REMARKS

DOCKET NO.: HITACHI-0012
Serial No.: 09/650,506
Amdt. dated April 27, 2004
Response to Office Action of October 27, 2003
Annotated Version

FIG. 1

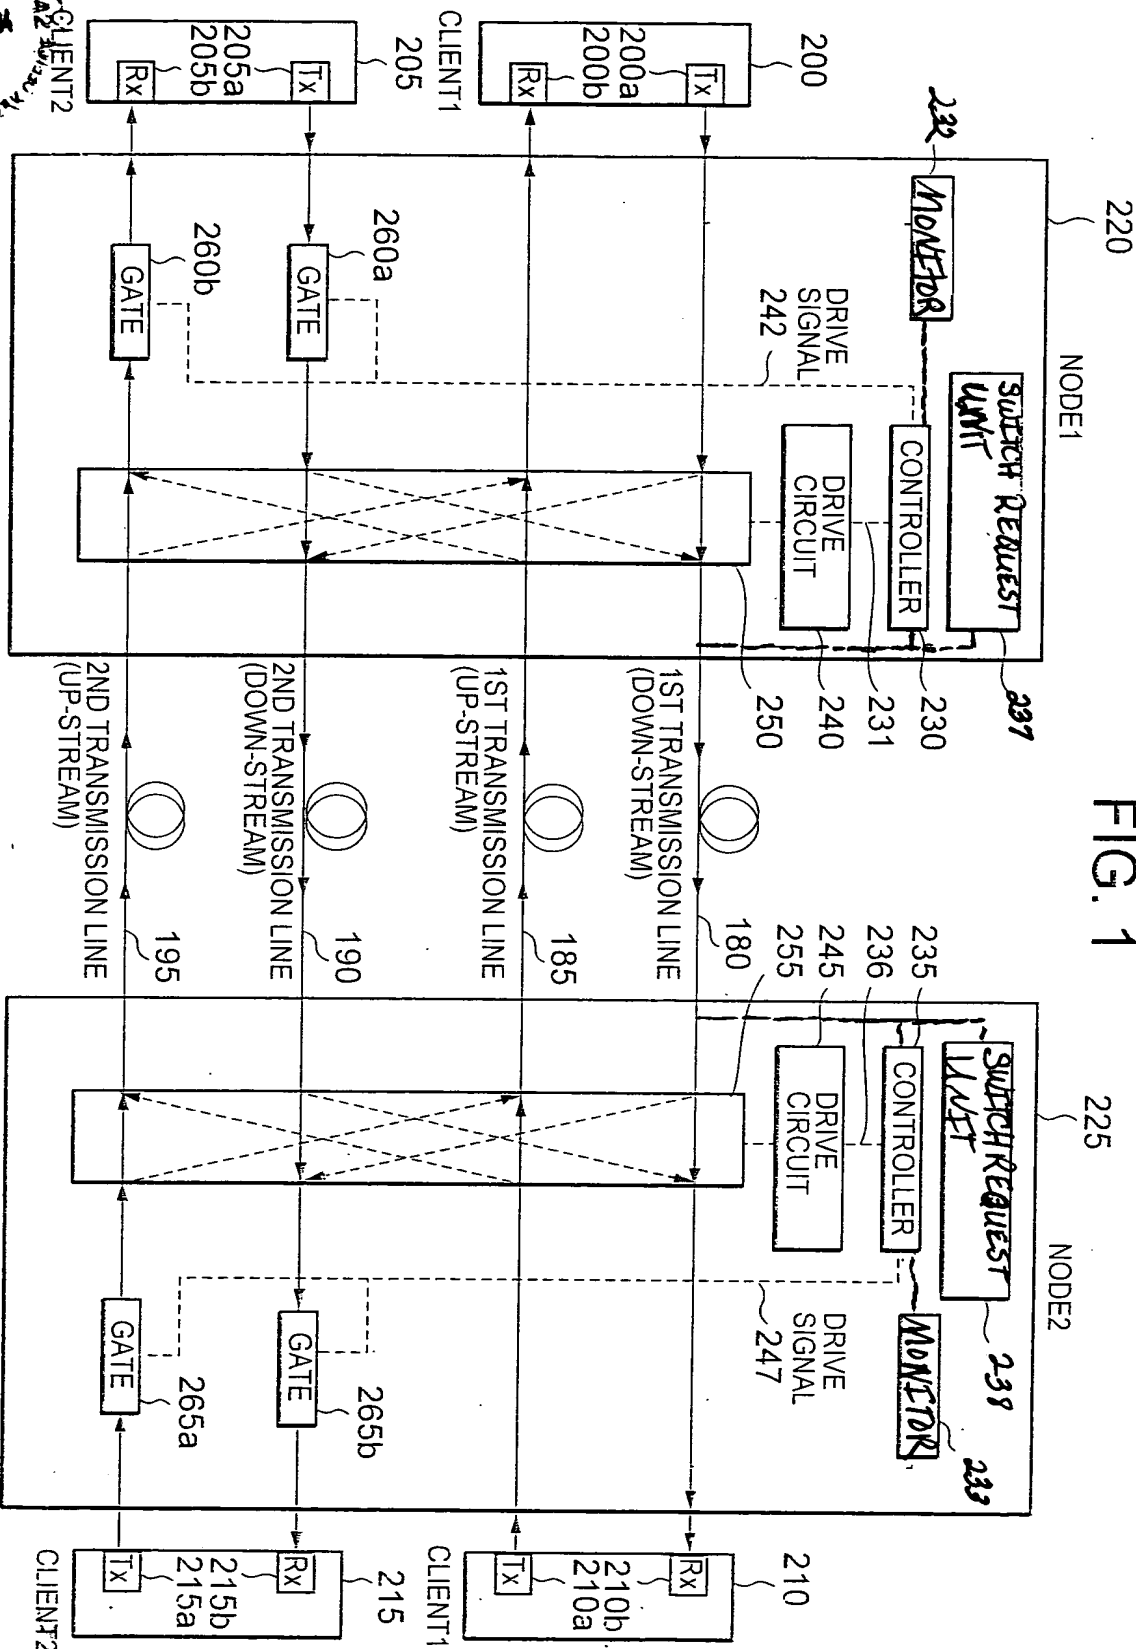
With respect to claims 19 and 32, to clarify the support for the subject matter limitations, FIGURE 1 has been amended to include the monitor 232, 233 and the switch request unit 237, 238. These elements have been supported by the original disclosures at lines 21 and 25 on page 6 of the current application. In this regard, the reference numerals of these originally supported elements are also incorporated in the specification on page 6. For the above reasons, the Applicants respectfully submit to the Examiner that the additional claim and drawing amendments should be entered.

(PRIOR ART) FIG. 12A

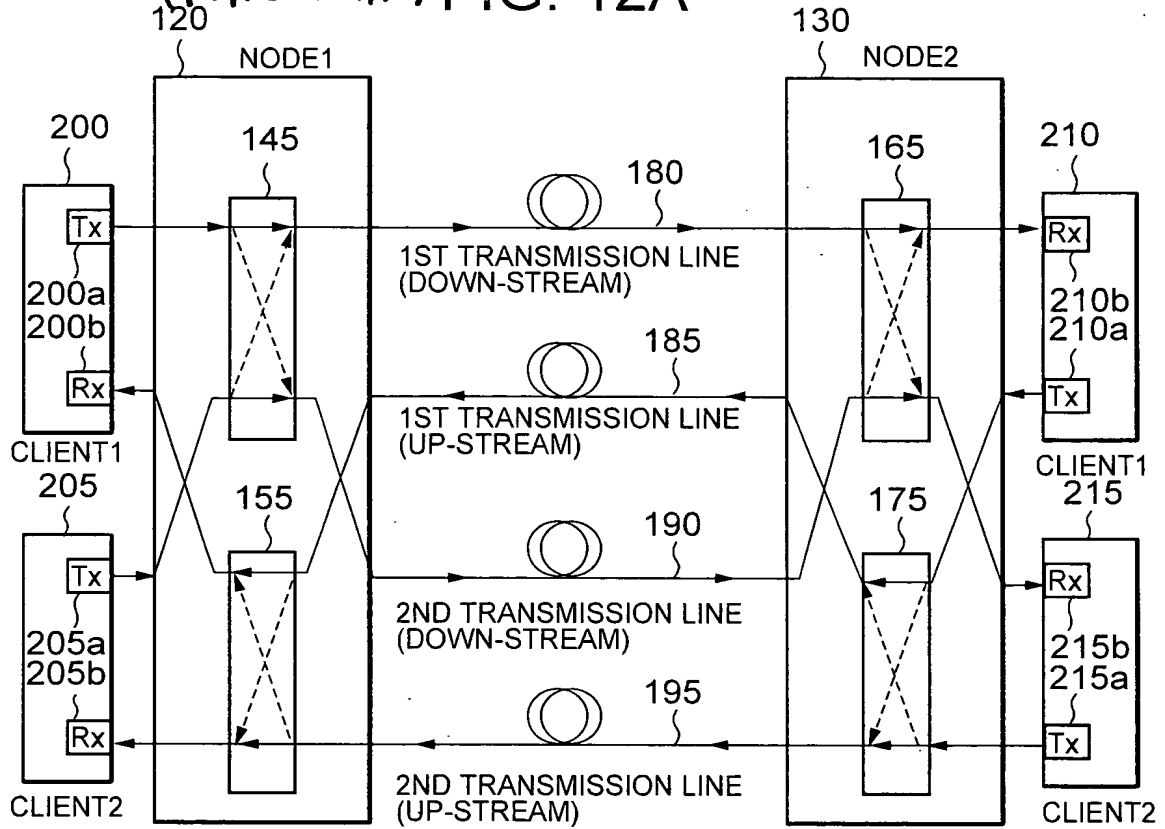
The Examiner has objected to FIGURES 12A, 12B and 13 for the lack of a prior art legend. Accordingly, the Applicants corrected the drawings to incorporate a prior art label as the Examiner has kindly suggested. Thus, the Applicants respectfully submit to the Examiner that that the drawing objections should be withdrawn.
